**NRC RAI Letter No. PTN-RAI-LTR-041**

**SRP Section: 02.05.01 - Basic Geologic and Seismic Information**

**NRC RAI Number: 02.05.01-17 (eRAI 6024)**

Proposed Turkey Point Units 6 and 7  
Docket Nos. 52-040 and 52-041  
FPL Response to NRC RAI No. 02.05.01-17 (eRAI 6024)  
L-2013-236 Attachment 15 Page 4 of 112

Figure 1 Structure Contour Map of the Top of the Fort Thompson Formation

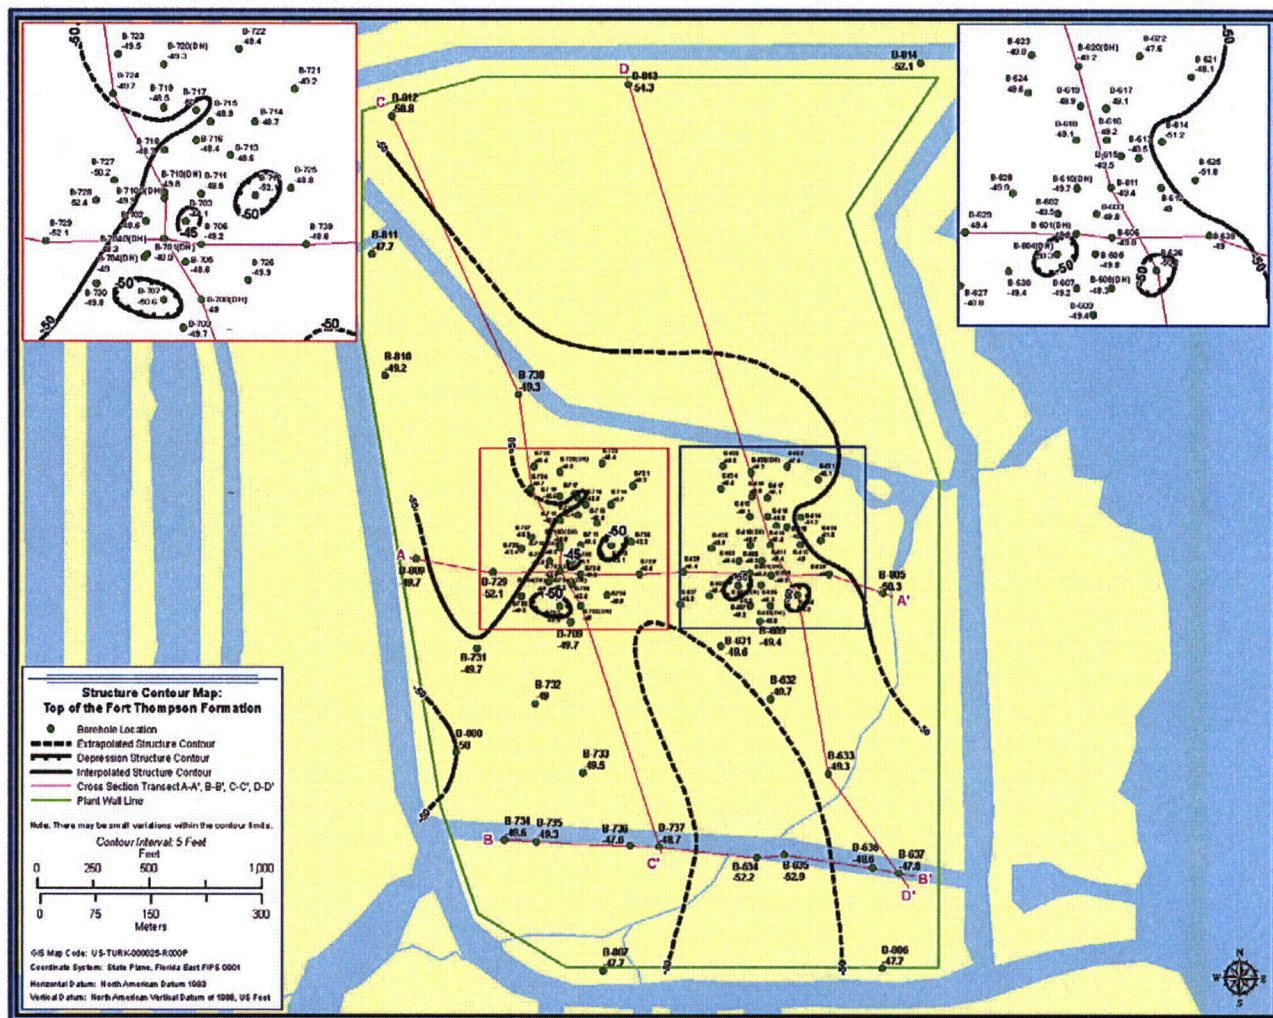
- a) Indicate the elevation on the structure contour maps and thickness values on the isopachs.
- b) Indicate thin areas on the isopachs and low areas on structure contours.
- c) Plot the location of cross section lines A, B, C, and D on the isopach and structure contour maps.
- d) Provide a structure contour for the Key Largo formation.
- e) The FSAR describes the Fort Thompson Formation as vuggy, and solution riddled. In light of this characteristic in the underlying Fort Thompson, discuss the implication of the numerous closed circles shown on the Key Largo isopach.

Revised structure contour maps showing the elevations of the top of the Fort Thompson Formation and the top of the Key Largo Limestone are provided in Figures 1 and 2, respectively. Revised isopach maps including thickness values of the Fort Thompson Formation and the Key Largo Limestone are provided in Figures 3 and 4.

The locations of cross section lines A, B, C, and D are shown on Figures 1, 2, 3, and 4.

Comparison of Figure 4 (Isopach Map of the Key Largo Limestone) and Figure 1 (Structure Contour Map of the Top of the Fort Thompson Formation) suggests that there is no strong correlation between the thickness of the Key Largo Limestone and the topography at the top of the Fort Thompson Formation. There are no co-located and similarly oriented closed-contour depressions on the two maps. This observation suggests the absence of a large collapse feature within the Fort Thompson Formation that extends upward into the Key Largo Limestone. The broad depressions with 2 to 3 feet (0.6 to 0.9 meters) of relief shown on the top of the Fort Thompson Formation in the vicinity of borings B-634 and B-729 (Figure 1) may be an expression of paleodrainage. That paleodrainage may be reflected in the broad relatively thin zones in the same areas of the Key Largo Limestone shown on Figure 4. This relationship may be a reflection of the underlying topography on which the Key Largo Limestone was deposited.

Similarly, there does not appear to be a strong correlation between Figure 1 and Figure 2 (Structure Contour Map of the Top of the Key Largo Limestone). Although both maps show a depression in the area of soil boring B-727, the topographic relief within the depression on the surface of the Fort Thompson Formation in this area is approximately 2.5 feet (0.8 meters), whereas the topographic relief in the depression on the surface of the overlying Key Largo Limestone in the same area is approximately 10 feet (3 meters). It seems unlikely that subsidence of about 2.5 feet (0.8 meters) in the Fort Thompson Formation due to collapse of a hypothetical solution cavity would induce corresponding subsidence of about 10 (3 meters) feet in the Key Largo Limestone.

Figure 4 Isopach Map of the Key Largo Limestone

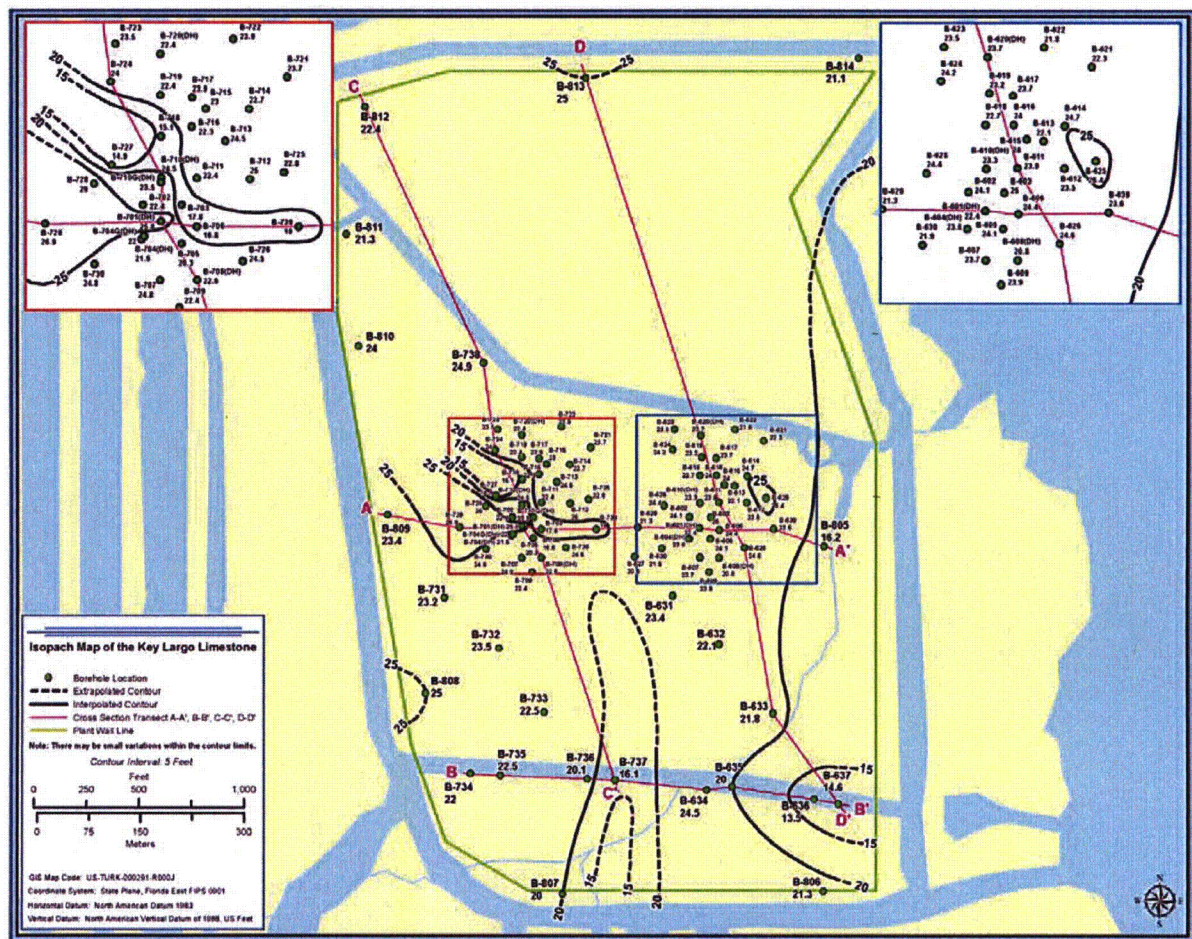
**e) The FSAR describes the Fort Thompson Formation as vuggy, and solution-riddled. In light of this characteristic in the underlying Fort Thompson, discuss the implication of the numerous closed circles shown on the Key Largo isopach.**

A relatively thin area in the Fort Thompson Formation is shown on Figure 3 in the vicinity of boring B-805. Relatively thin areas in the Key Largo Limestone are shown on Figure 4 in the vicinity of borings B-636, B-727, and B-737. Relatively low areas in the top of the Fort Thompson Formation are shown on Figure 1 in the vicinity of borings B-625, B-634, B-712, and B-728. Relatively low areas in the top of the Key Largo Limestone are shown on Figure 2 in the vicinity of borings B-636, B-706, and B-727, B-737, and B-738.

It can be noted that, with one exception, in the few instances where closed-contour depressions have been mapped on the structure contour and isopach maps the topographic relief within the depressions is no more than one or two feet (0.3 to 0.6 meters). This observation suggests that the topography of the top surface of both the Key Largo Limestone and Fort Thompson Formation is relatively flat. The one exception is on the top of the Key Largo Limestone (Figure 2) in the vicinity of boring B-706, where the topographic relief is approximately 6 feet (1.8 meters). Comparison with the isopach map of the Key Largo Limestone (Figure 4) reveals that boring B-706 is within a broad area of thinning of the unit that may be an expression of paleodrainage.

**Figure 2.5.1-342 Isopach Map of the Key Largo Limestone**  
This figure appears in Appendix 2.5AA as Figure 2.5AA-207

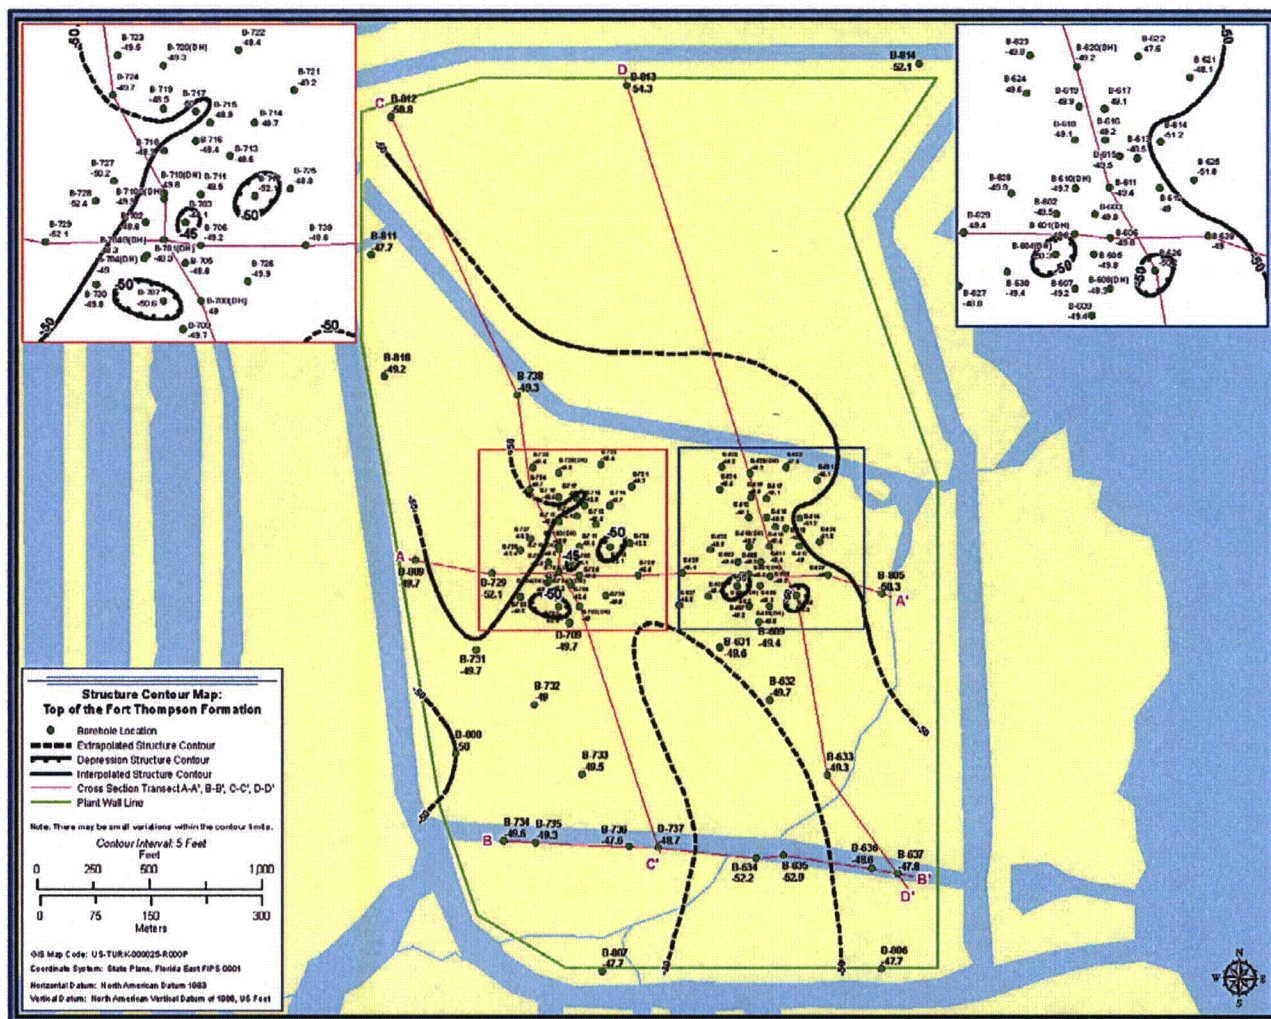
FSAR Figures 2.5.1-342, -343, and -344 illustrate isopach and structure contour maps of the Key Largo Limestone and Fort Thompson Limestone stratigraphic units. The staff notes, however, that additional information is needed on the maps to understand the nature of the Key Largo and Fort Thompson limestone units.

Four geologic cross sections, two isopach (thickness) maps, ~~one~~**two** structure contour maps, and a site geologic map were prepared from the information obtained from the site subsurface investigation (Figure 2.5.1-336**4**). Geologic cross section A-A' (Figures 2.5.1-338 **and -386**) extends east-west through the power blocks and eight borings, including the two deepest borings B-601 and B-701. Cross section B-B' (Figures 2.5.1-339 **and -387**) extends west-east through the southern edge of the site and includes eight borings, the deepest at 153 feet (46.6 meters) bgs. Cross section C-C' (Figures 2.5.1-340 **and -388**) extends diagonally northwest-southeast through the entire site and passes through the western power block. Cross section C-C' includes seven borings including the deepest boring, B-701(DH), at a depth of 615.5 feet (187.6 meters) bgs. Cross section D-D' (Figures 2.5.1-341 **and -389**) also extends diagonally northwest-southeast through the entire site but passes through the eastern power block. Cross section D-D' includes six borings; the deepest at a depth of 215 feet (66 meters) bgs.
